Three Questions from NRC.

Figure 1. Exploded view of the tritium source, protective borosilicate sleeve and metal protective base in a front sight. Rear sight is similar.

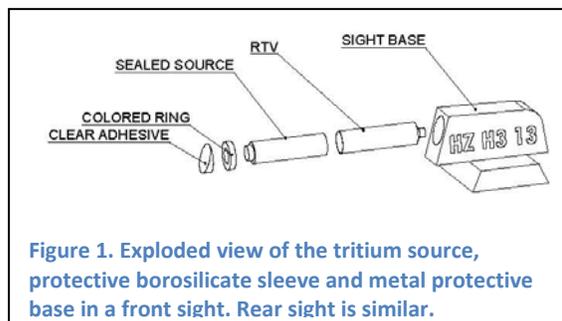
a. In Attachment J, “Dose Calculations,” Selection D, “Accident Scenarios Considered,” for Scenarios 1 and 2, you assume that 5 percent and 1 percent of devices, respectively, are destroyed in the conceived fire conditions. Please explain why these particular percentages were selected and why the probability of these scenarios is considered to be “low.” Furthermore, please explain why the probability of Scenarios 4 and 5 are considered to be “low,” and why the probabilities of Scenarios 3 and 6 are considered to be “negligible.”

Please explain why these particular percentages (5 percent and 1 percent of devices for Scenarios 1 and 2, respectively) were selected and why the probability of these scenarios is considered to be ‘low.’”

These devices consist of gaseous ^3H (tritium) sealed into a protective base (Fig. 1) that is constructed of borosilicate glass. Borosilicate glass is high-temperature resistant and is used for laboratory glassware (e.g., beakers and flasks) which is subjected to quite high temperatures. Borosilicate glass (sold under such trade names as Pyrex, Endural and Schott) is highly temperature resistant. The softening point of Pyrex is $820\text{ }^\circ\text{C}$ ($1,510\text{ }^\circ\text{F}$). It is also used in implantable medical devices and devices used in space applications, where ruggedness and a very high degree of reliability are essential. Additionally, the glass cylinder containing the tritium source is well protected within a metal mounting bracket (Fig. 1, 2 and 3).

Borosilicate glass is known for having very low coefficients of thermal expansion, making it resistant to thermal shock, which reduces material stresses caused by temperature gradients. All of these attributes make borosilicate an excellent material for use in tritium gun sights.
